**Response to Referee Comment 1 (RC1) from Anonymous Referee # 1** (*Referee comment in Italic, response in blue*).

**RC1:** ['Comment on essd-2024-168'](#), Anonymous Referee #1

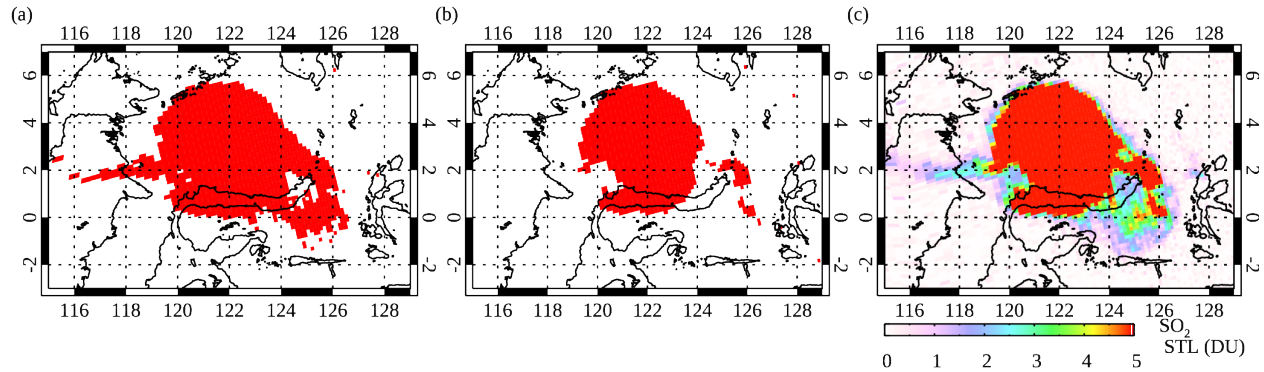
*I 183: (new volcanic screening): What is the impact? are there now more, or less pixels flagged?*

As shown in Figure 1 below, the new volcanic SO<sub>2</sub> flagging scheme is more sensitive and flags more pixels as compared with the old scheme. For NOAA-20/OMPS, the new scheme flags pixels with STL SO<sub>2</sub> of ~2 DU and above, whereas the old scheme flags pixels with STL SO<sub>2</sub> of ~5 DU and above. We have added this information to the revised manuscript and the figure to the supplemental information (Fig. S1).

Figure 2. Same as Fig. 2a in the paper manuscript but with N20/OMPS retrievals conducted without subsectors.

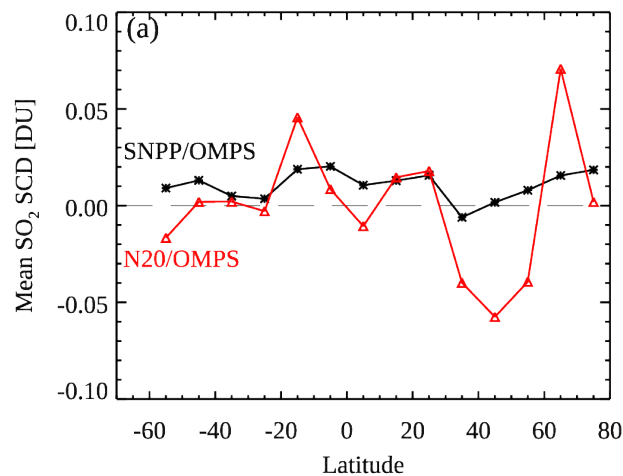
I 194: "five subsectors". Are these five latitude bands? Why is this important? Please add a few lines to explain the subsectors.

*Fig.2 left seems to indicate jumps in the NH. Is this within the noise, or linked somehow to the subsectors?*

We have clarified in the paper that these bands are based on latitudes and solar zenith angles. We previously found that they help to reduce retrieval biases. In addition, we have conducted a test without using the subsectors and confirmed that for NOAA-20, the use of subsector does reduce retrieval biases (see Figure 2 below). The figure and relevant discussion have been added in the supplemental information (Fig. S4) and section 3.1 of the paper, respectively.

As mentioned above, we conducted a test without using the subsectors and the results suggest that the use of subsectors helps to reduce retrieval biases (and jumps).

Figure 3. SO<sub>2</sub> vertical column densities (VCDs) for April 1, 2020, retrieved from N20/OMPS using (a) the same algorithm settings as for SNPP/OMPS, and (b) the updated algorithm settings. A constant air mass factor (AMF) of 0.36 is applied to all pixels in both retrievals.

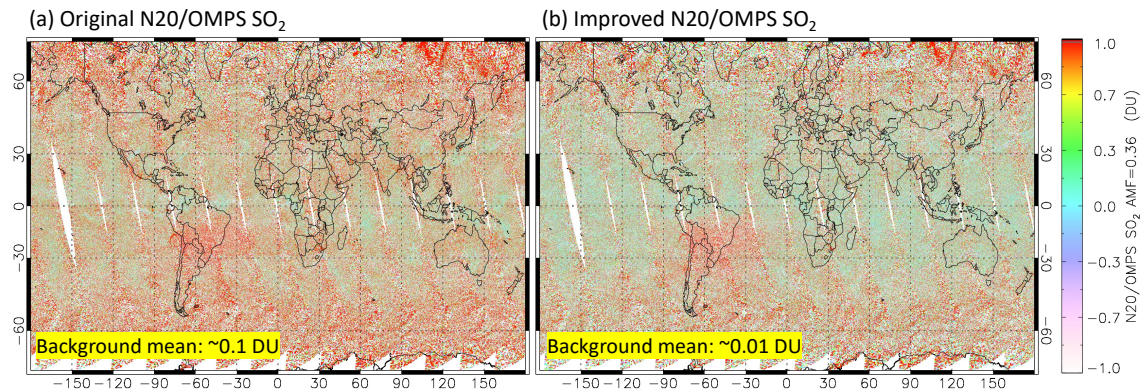
*The biases seem to be linked to changes in the algorithm, and especially the threshold for SO2 containing pixels. In Figs 6 and 7 the product is again bias corrected to check consistency with SNPP. This leaves the question why the procedure was changed in N20 after all. Why do you bias-correct N20 and not SNPP? It would be useful to extend the discussion on this. Does the old procedure lead to problems for N20? If so, where do the problems occur and how big are these problems?*

We previously tested the OMI/OMPS SO<sub>2</sub> algorithm with N20/OMPS with minimal changes in algorithm settings and noticed a substantial positive bias over background areas (see Figure 3 below) that is not noticeable in our OMI or SNPP/OMPS retrievals. To reduce this bias, we updated several algorithm settings, including the threshold for

SO<sub>2</sub> containing pixels, with N20/OMPS (see Figure 3b below). We have added the figure to the supplemental information (Fig. S3).

As for using SNPP/OMPS as the reference to bias-correct N20, the choice is made based on 1) the longer and more established data record from SNPP; 2) relatively good consistency between SNPP/OMPS and OMI (e.g., Li et al., 2017; Zhang et al., 2017), and 3) the fact that substantial calibration work is still ongoing for N20/OMPS. We have added this explanation to the revised manuscript.

Figure 4. Relative contribution of individual satellite instruments to the weighted average for emissions estimate depending on the emission strength for 2018-2023.

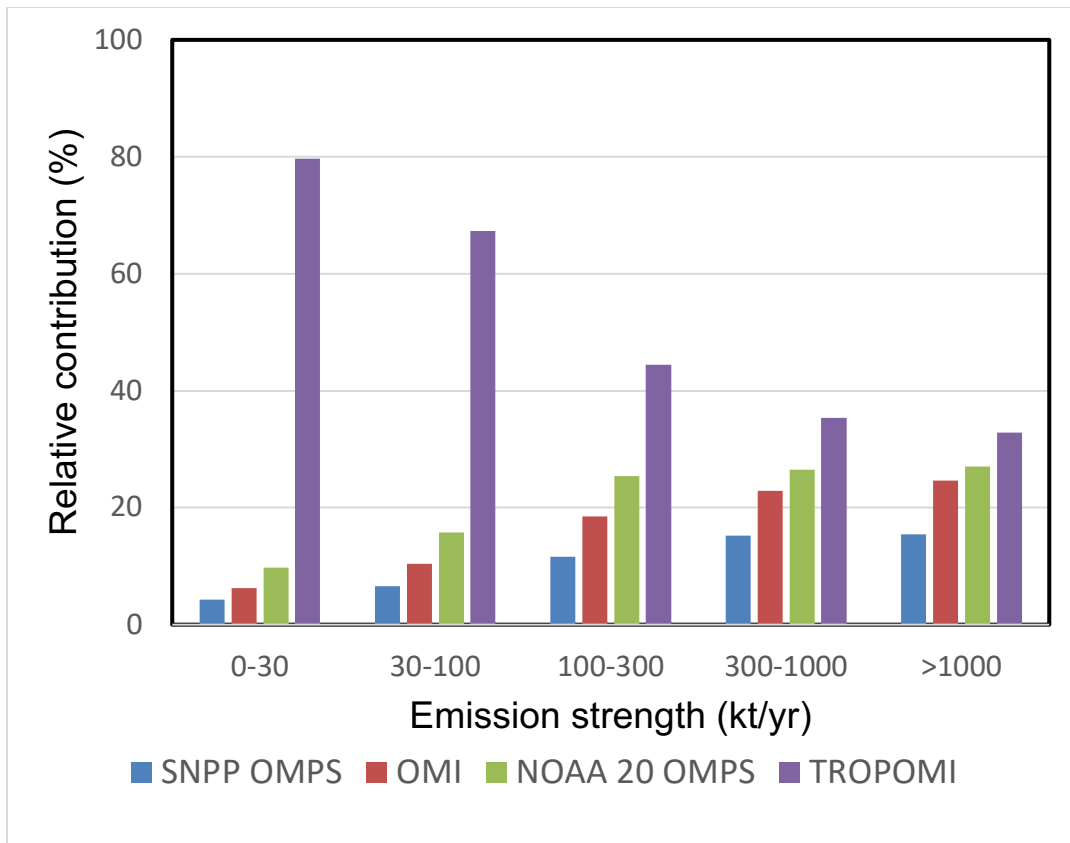
*I 448: A weighted average based on inverse variances is suitable for unbiased datasets. In the average of the four platforms algorithm and instrument differences play a role. Why did the authors choose this approach?*

Please note that the emission estimation algorithm removes local biases, so we are averaging unbiased datasets even if the original satellite SO<sub>2</sub> data have some biases.

This inverse variances-based approach was introduced in Version 2 of the SO<sub>2</sub> emissions catalogue (<https://essd.copernicus.org/articles/15/75/2023/>) when it was necessary to combine emission estimates from several satellite instruments with very different emission uncertainties.

The contribution of individual satellite sources as a function of the source emission strength is shown in the figure below (Figure 4). For small sources (under 30 kt/year), only TROPOMI was able to produce emission estimates with low uncertainties. For large sources, all satellite instruments can be used for emission estimates. So, in the former case, the weighted average was based mostly on TROPOMI data, while in the latter case, all satellite instruments provided comparable contributions. NOAA-20/OMPS based emission estimates have slightly smaller uncertainties compared to OMI, as also reflected by the weighting coefficients. The Figure below has been added to the supplemental information (Fig. S7)
